# Product Change Notification

Product Group: Film capacitors/ February 25, 2009/PCN-FC-007-2008 Rev 0

## **F1772 - 2 series X2 capacitors upgrade to 310 Vac, 110°C and miniaturization of dimensions**

**Annexure 1 :**

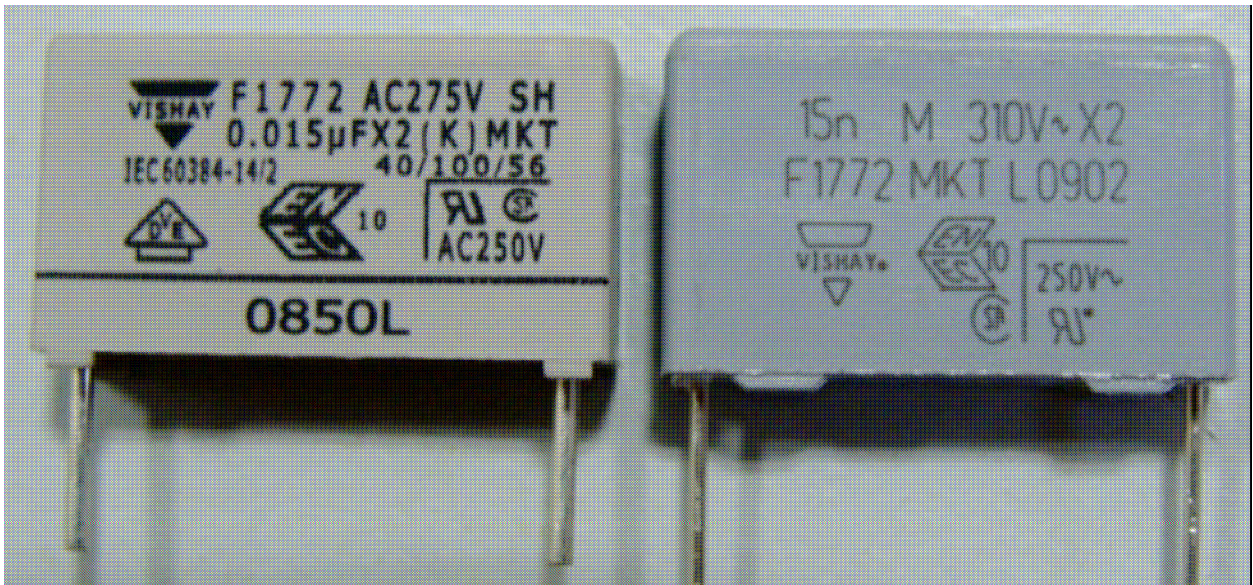
Voltage: 310 V~ will be marked on capacitor and label. Change in dimensions and lead diameter  
See annexure.
